# DEVELOPMENT REVIEW COMMITTEE

## 580 BRINY AVENUE APARTMENTS – Site Plan

**Request:** Major Site Plan  
**P&Z Number:** 22-12000043  
**Owner:** Claridge Homes Beachboys LP  
**Project Location:** 580 Briny Avenue  
**Folio Number:** 494306060260  
**Land Use Designation:** Medium-High (MH 16-25 DU/Acre)  
**Zoning District:** RM-20/AOD (Multiple-Family Residential 20 /Atlantic Overlay District)  
**Commission District:** Andrea McGee (District 1)  
**Agent:** Andrew J. Schein  
**Project Planner:** Diego Guevara (954-786-4310 [diego.guevara@copbfl.com](mailto:diego.guevara@copbfl.com))

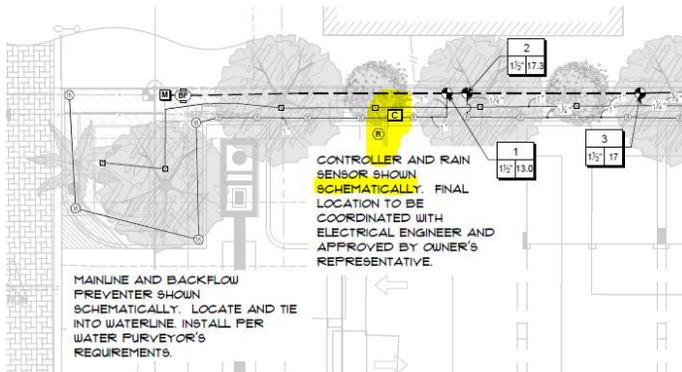
44. Staff requirement: Provide medium canopy trees in parking islands along rear drive aisle.

**RESPONSE: Silver Buttonwood(4) provided in parking island.**
